COUNTY ADMINISTRATORS OFFICE

October 25, 2012

Re: Rosemont Mine Proposal – Substantial Changes and New Information Require a New or Supplemental Draft Environmental Impact Statement

Figure 2. Two different configurations for the Rosemont open pit, on U.S. Geological Survey topography, both intersect the crest of the Santa Rita Mountains. (Sources: U.S. Forest Service 2011 in purple; CDMSmith 2012 in pink).

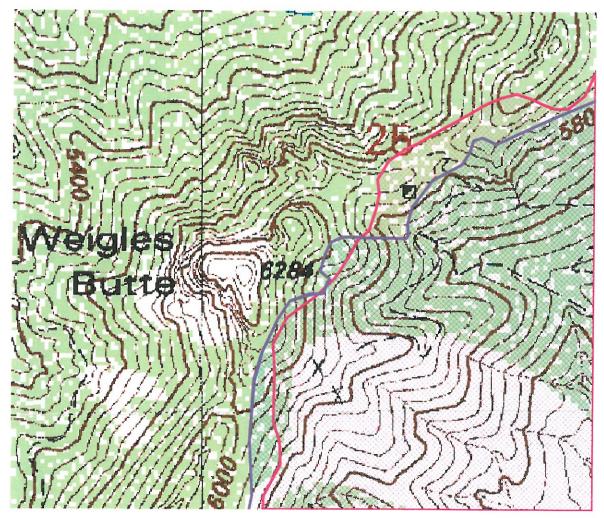
No previous efforts have been made to minimize the footprint of the processing areas. The recent deletion of the SXEW facilities and change in approach to routing stormwater now provide the Forest Service and Rosemont Copper with an opportunity to consolidate the footprint of the mineral processing areas. In addition, our information suggests the top of the pit(s) (as proposed in both the Mine Plan of Operation and in the new proposed action) will intersect the crest of the Santa Rita Mountains (see Figure 2 below). Efforts to

minimize and mitigate the pit impacts to visual resources, water quality, aquifer conditions, and talus snails must be made.
